KEMPS CREEK ESTATE – SSD-9522 MOD 3

Section 4.55 (1A) Modification

Prepared for
**FRASERS PROPERTY INDUSTRIAL & ALTIS
PROPERTY PARTNERS**
26 November 2021

Figure 6 MOD 3 Lots 1-4 Master Plan

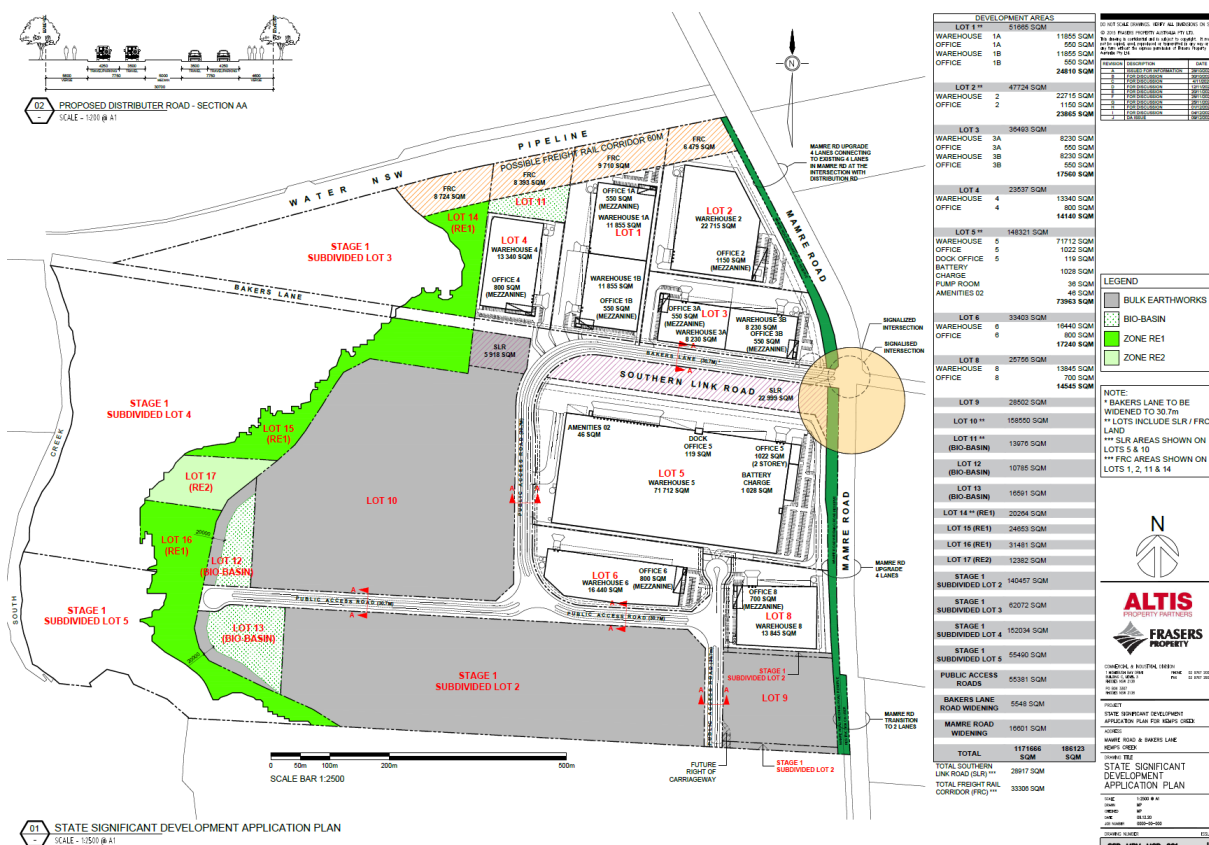
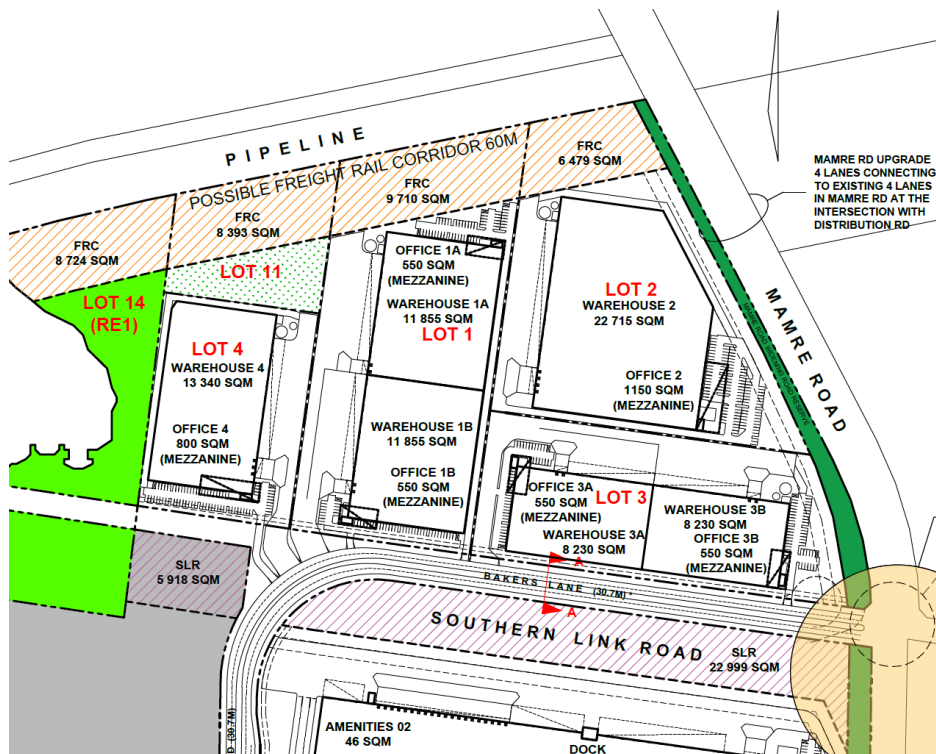
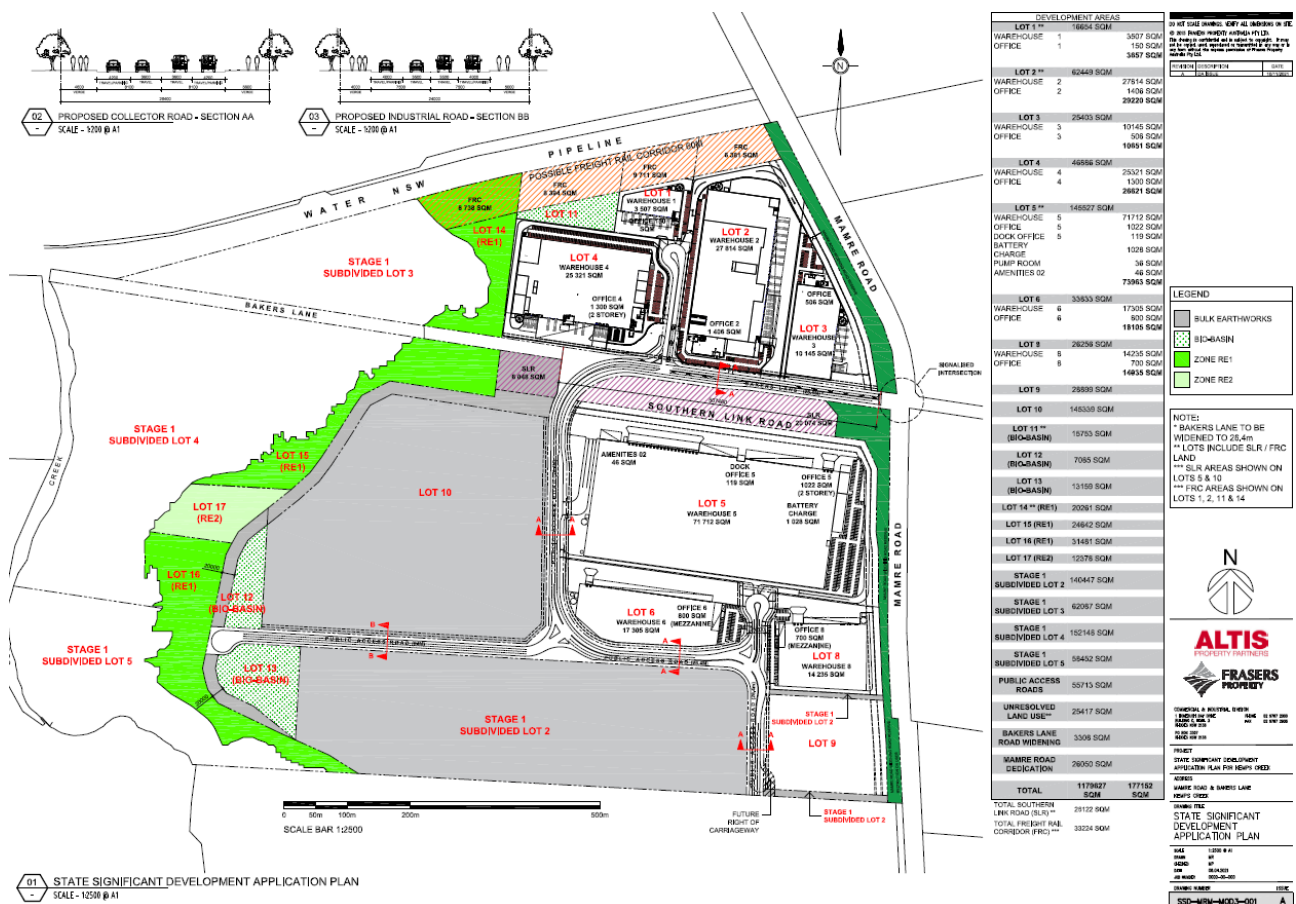
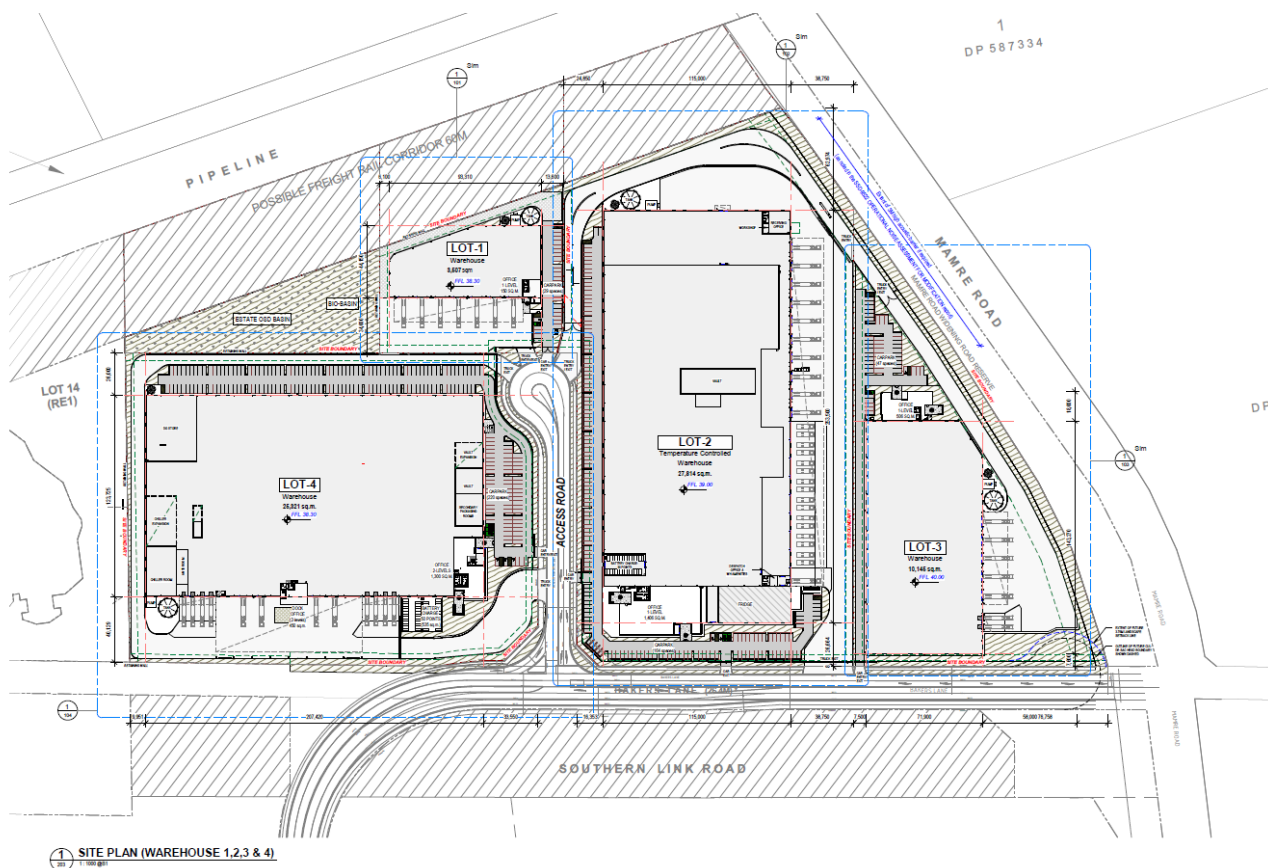
The proposed modification includes the following estate layout changes, north of Bakers Lane, which are set out on plan extracts at **Figure 5** and **Figure 6**, and in the accompanying architectural plan set at **Appendix A**:

MOD 3 seeks to revise the layout (refer **Figure 5** and **6**) in response to tenancy requirements for Warehouses 2 and 4 being the two largest warehouses with a direct frontage to the new cul-de-sac road. Warehouse 1 has been redesigned as the smallest warehouse situated at the northern periphery of the site along the Warragamba Pipeline. Warehouse 3 is redesigned in a north-south orientation with frontage to Bakers Lane and Mamre Road but maintaining access off the new cul-de-sac road. There is also an increase in the Lot 11 site area which consists of the bio-basin within the north of the site.

Figure 7 MOD 3 Warehouse 4 awning location

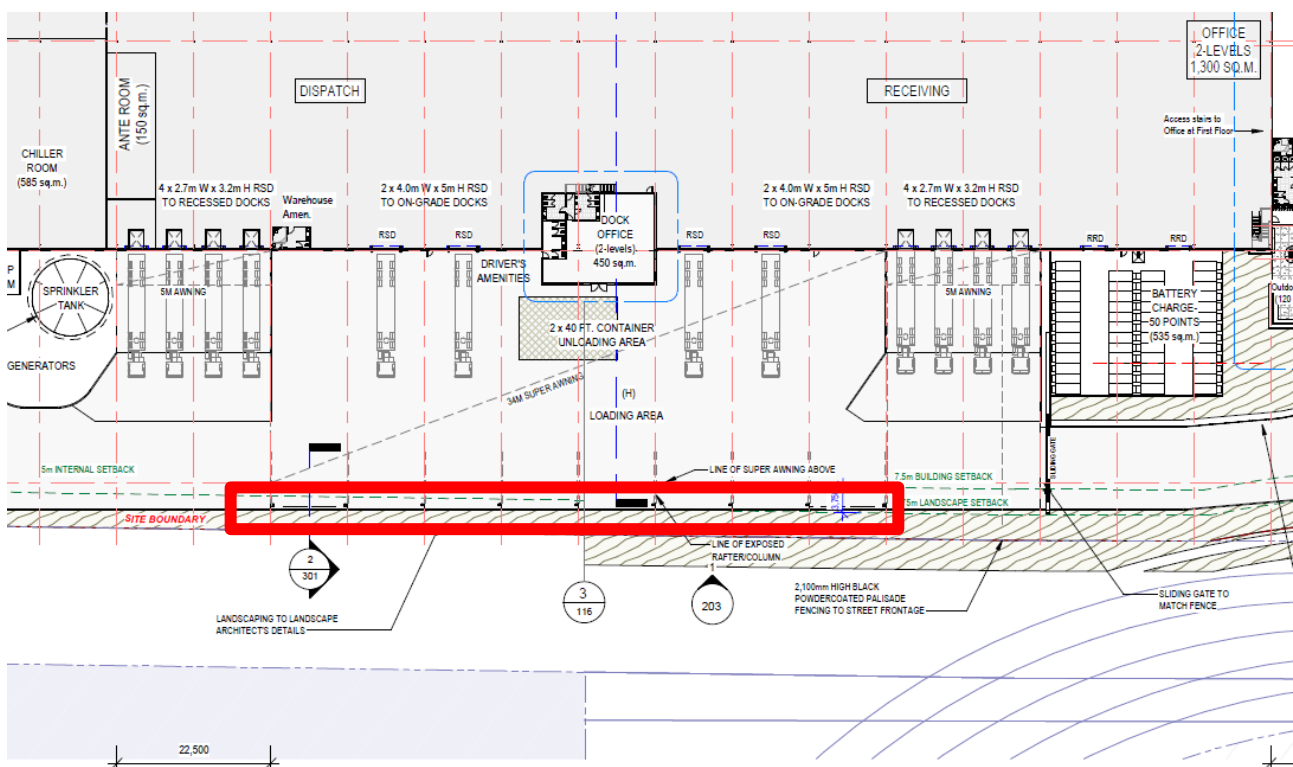
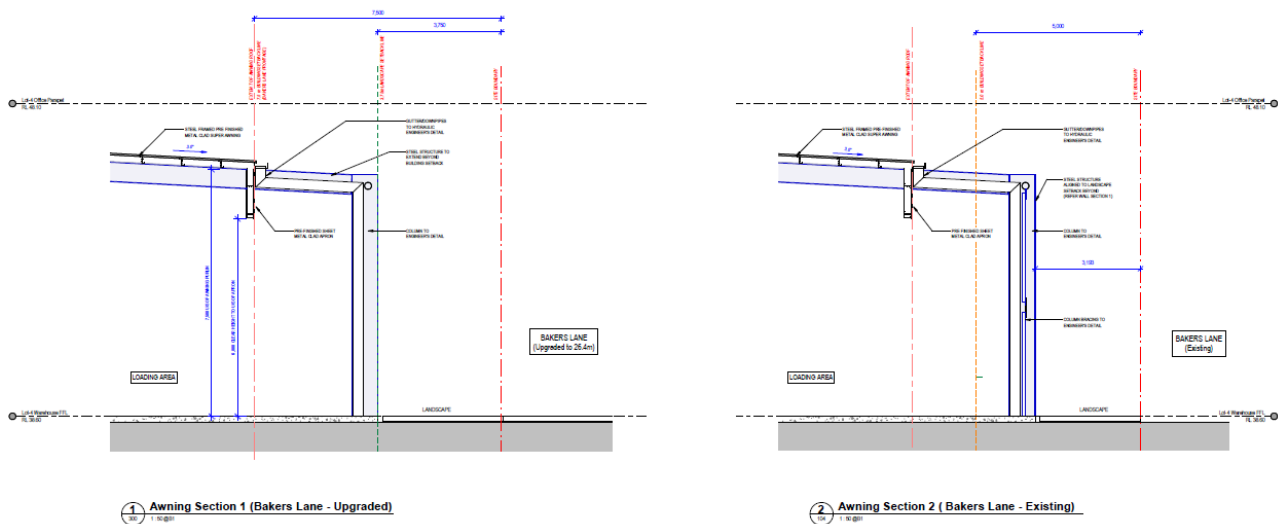
In relation to Warehouse 4, the MOD 3 layout includes super-awning columns within the setback area along the southern boundary of Lot 4, and to the immediate north of the Bakers Lane reserve corridor (refer **Figure 7**). The roof structure for Warehouse 4 to the south stops at the building setback (7.5m from the site boundary) with the roof support structures situated within the landscape setback (3.75m from the site boundary). Locating the roof support structures within the landscape setback is to enable a more useable hardstand area for Warehouse 4, given it also contains an access way for vehicles to exit the Lot 4 which wraps around Warehouse 4.

The proposed nine support structures will have dimensions of approximately 800mm (width) by 250mm (depth) and 7,000mm in height, and will be of steel construction. They are considered to have a minimal impact on visual amenity along Bakers Lane given the narrow width and scale of the columns and the landscape and vegetation screening provided along the Lot 4 boundary. Balancing the efficiency improvements achieved by their locate in the landscaped setback area with their low visual impact, it is considered that the proposed design response is acceptable.

Figure 9 MOD 3 Acoustic barrier along part of the the Lot 2 and Lot 3 boundary with Mamre Road

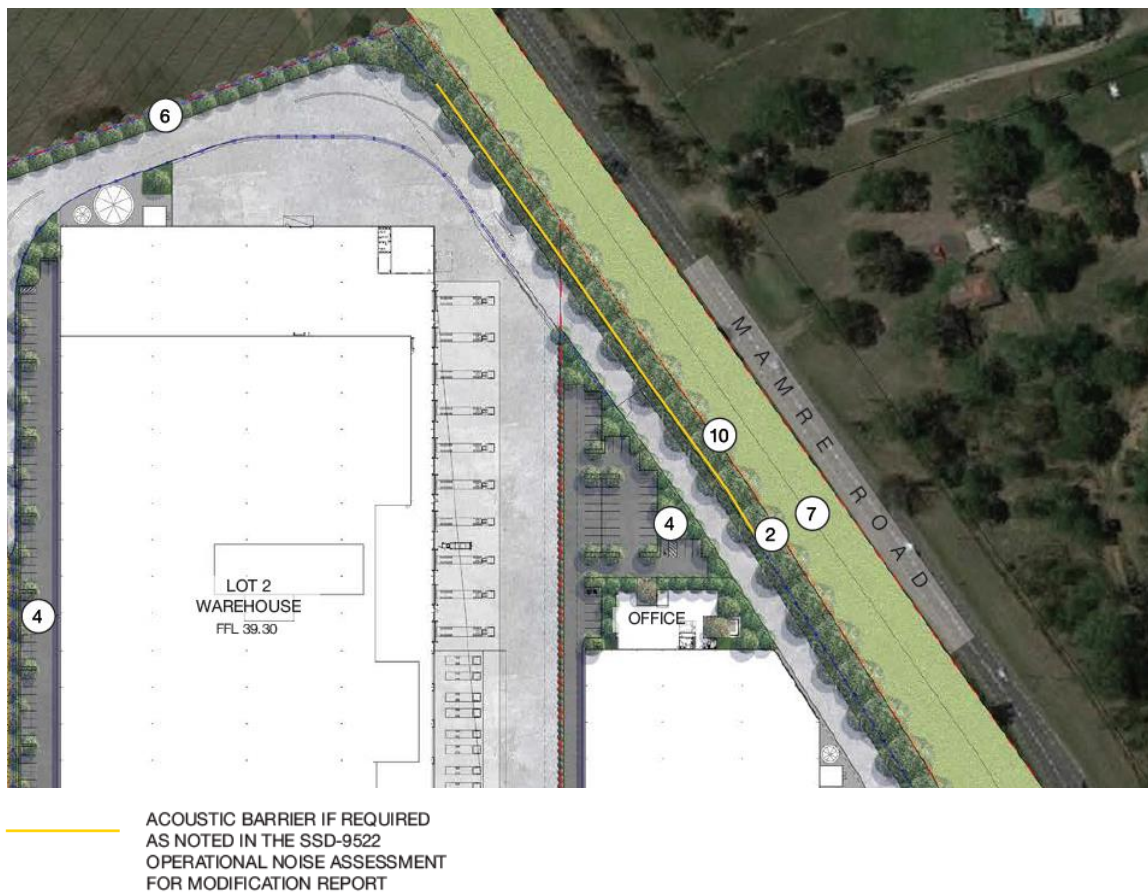
The modification of Condition B54 is to ensure provision of an acoustic wall along the Lot 2 frontage with Mamre Road to screen noise emanating from Warehouse 2, so to mitigate sleep disturbance at the R2 residential receiver. As the lot on which residential receiver R2 is located is currently the subject of a sales marketing campaign to an industrial developer, this acoustic barrier is only required if residential receiver R2 is occupied when Lot 2 is operational, or if it is planned to be occupied in the future. Further details are provided in Section 8.4 of this report.

The Applicant must construct the acoustic barrier for Warehouse 2 as shown in the site plan SP-KC1-DA-003, prepared by Frasers Property Australia Pty Ltd, dated 15 November 2021, prior to the commencement of operation of Warehouse 2, only should the residence at the R2 residential receiver be occupied at the commencement of operations of Lot 2. If the dwelling at R2 is not occupied at operational commencement and is not planned to be occupied in the future, the acoustic at this location is not required.

Figure 16 MOD 3 – Indicative Rooftop Air Conditioning Plant on Warehouses 2 and 4

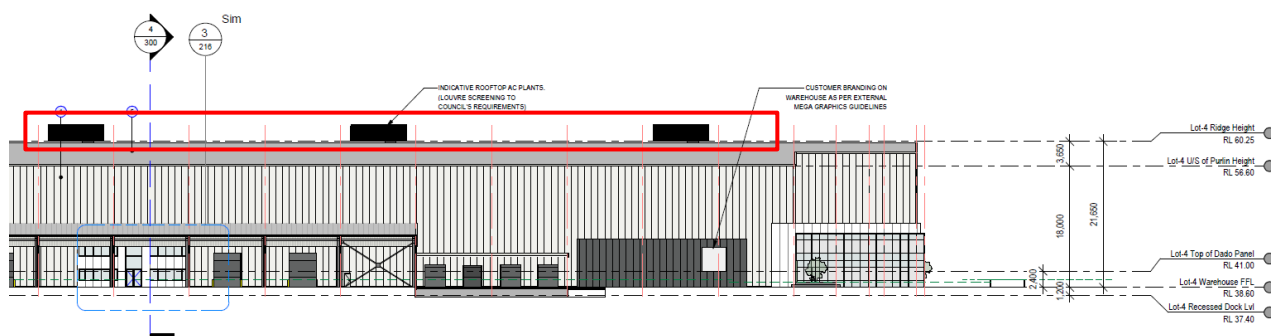
As part of MOD 3, Warehouses 2 and 4 will incorporate a series of rooftop air conditioning plant structures which include louvre screening in accordance with Penrith City Council's requirements (refer **Figure 16**). This plant will have a negligible impact on the visual impact on Warehouses 2 and 4, given the location and scale of the plants in relation to the warehouses, as indicated in the VIA.

Figure 18 MOD 3 – Reduced access points off Bakers Lane from 7 to 4

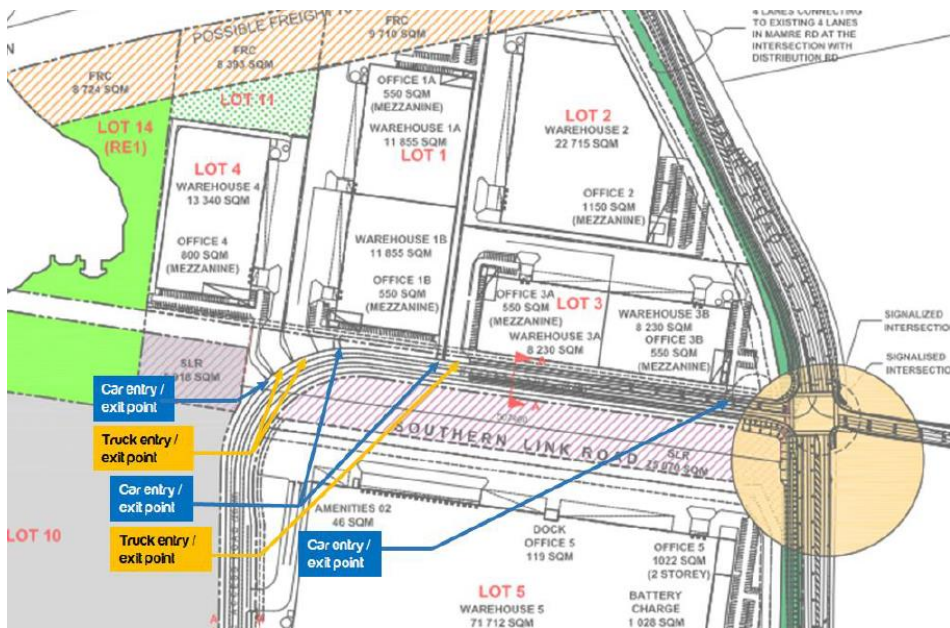
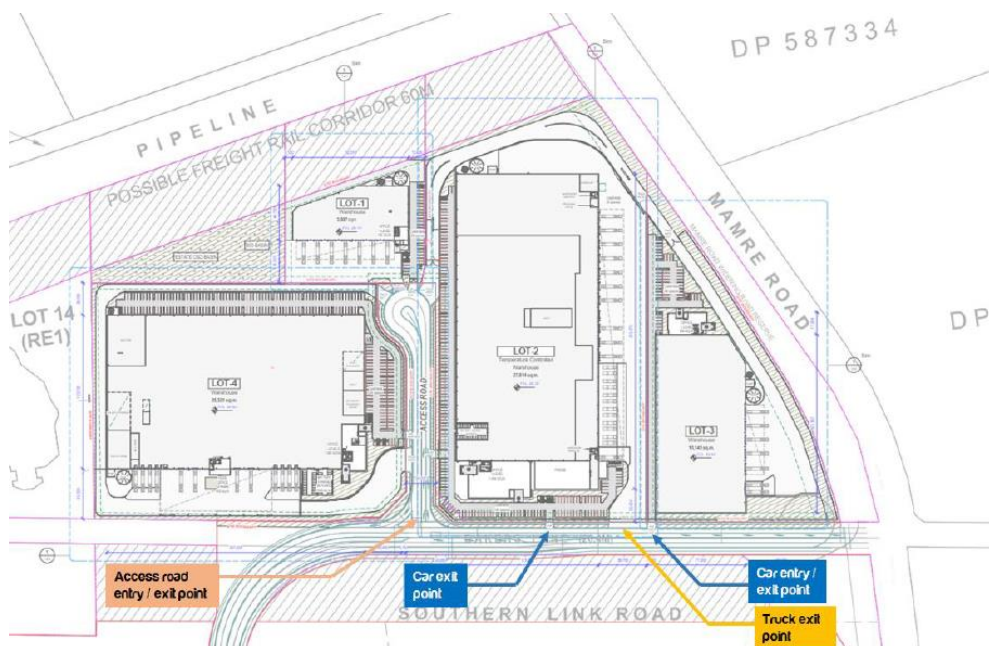
Condition B18 is proposed to be deleted as this modification directly addresses the requirements of this condition through the introduction of the new cul-de-sac road from which all warehouse lots will gain access. The new road will reduce the number of crossings from Bakers Lane from 7 to 4.

The inclusion of an access road off Bakers Lane provides access to Lots 1-4, reducing the access points along Bakers Lane from six (6) to four (4) (refer **Figure 17** and **Figure 18**). The proposed modification also removes driveway access previously proposed adjacent to the Southern Link Road which directly impacted on the future signalised intersection with Bakers Lane. The access road enables the reduction in access points and provides the internal road network to Lots 1-4 in response to Condition B18. The access road is proposed at a suitable distance from the future intersection at 140m, which meets the minimum requirement of 100m separation from TfNSW.

Figure 20 Extent of acoustic barrier to mitigate potential sleep disturbance impacts at receiver R2

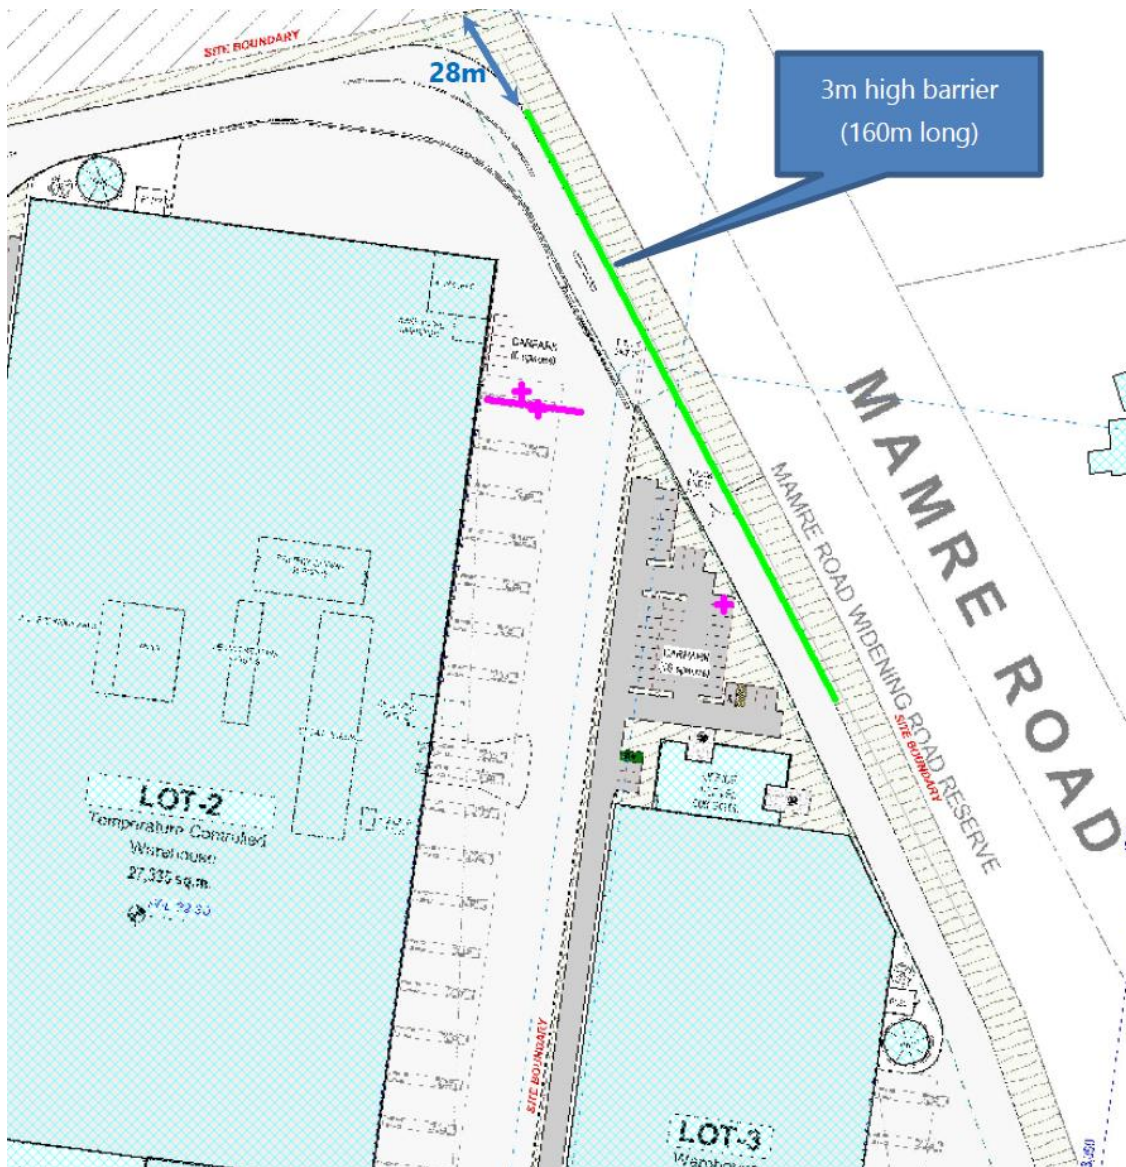
As such, noise mitigation and management measures are identified to address the predicted sleep disturbance impacts including the installation of a 160m long and 3m high noise wall along the eastern boundary of the site along the Mamre Road frontage. Provision is to be made for installation of the barrier as shown in **Figure 20** in order to successfully mitigate sleep disturbance impacts for receiver R2. The noise barrier is not required in order to meet the sleep disturbance criteria for all other receivers.

Installation of the noise wall is only required should the residence at the R2 receiver be occupied at the commencement of operations in Lot 2. If the dwelling at R2 is not occupied at the time of operation for Lot 2, and/or is not planned to be occupied for residential purposes in the future, the barrier is not required as there will be no sleep disturbance impact to an unoccupied dwelling.

An update to condition B54 is proposed to this effect.
